MANUAL CHANGES

MODEL 5245L

ELECTRONIC COUNTER

Manual Serial Prefixed: 408-

Figure 5-5:

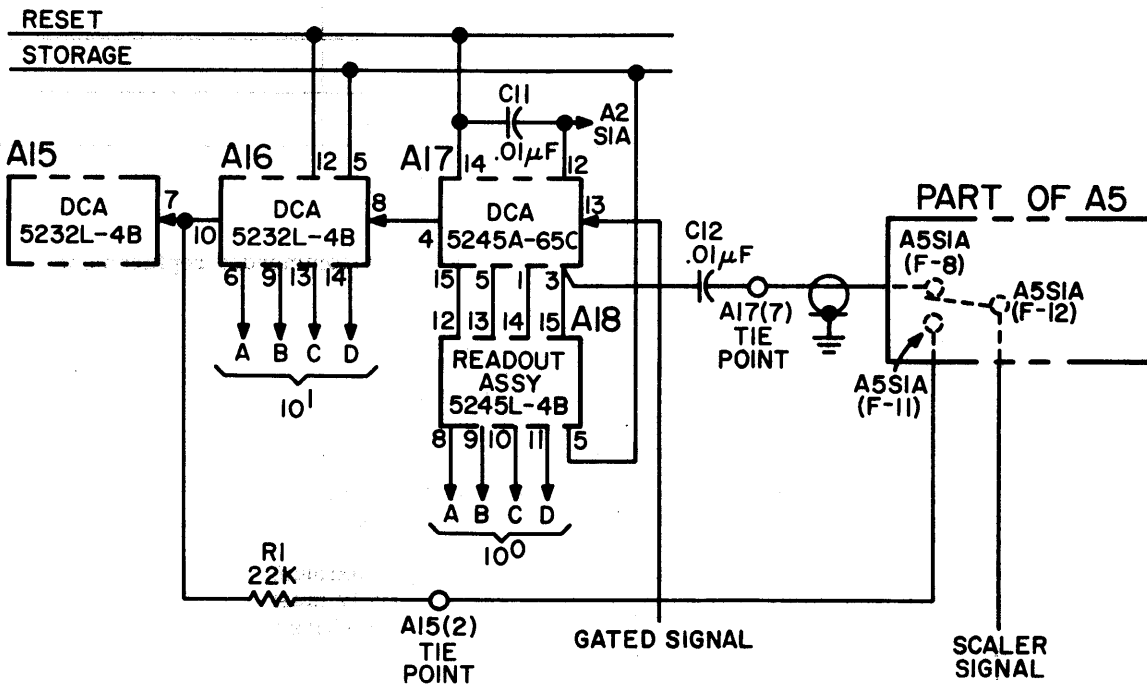
Correct Figure 5-5 as shown in Figure 1.

CHANGE 3

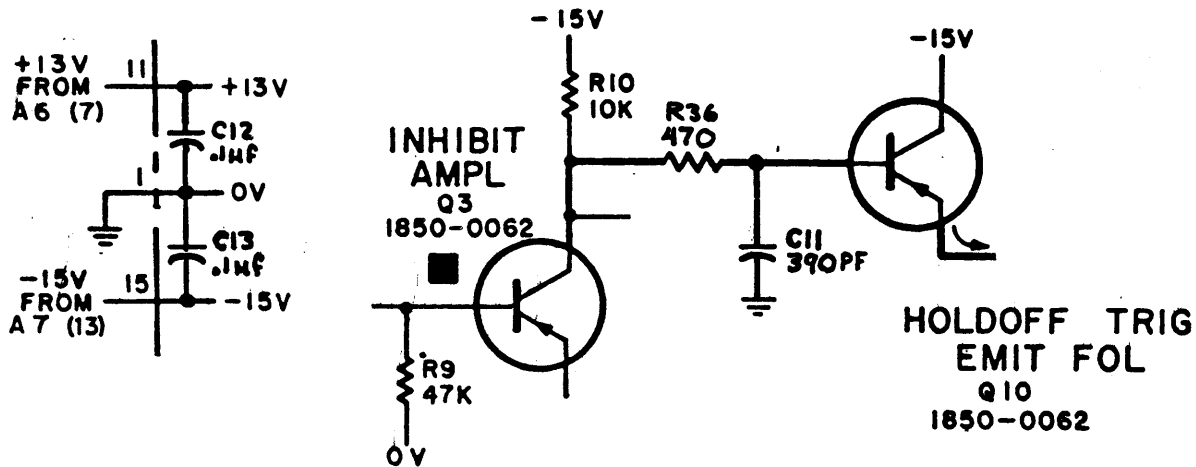
Figure 5-23, Table 6-1,
Change A17Q9 to $\text{\textcircled{P}}$ Stock No. 1850-0163.
Figure 5-32, Table 6-1,
Delete: C10 1000 pf $\text{\textcircled{P}}$ Stock No. 0140-0152.
Add: C11 390 pf $\text{\textcircled{P}}$ Stock No. 0140-0200.
Add: C12, 13 .1 μf $\text{\textcircled{P}}$ Stock No. 0150-0121.
Add: R36 470 ohms $\text{\textcircled{P}}$ Stock No. 0686-4715.
See schematic below.
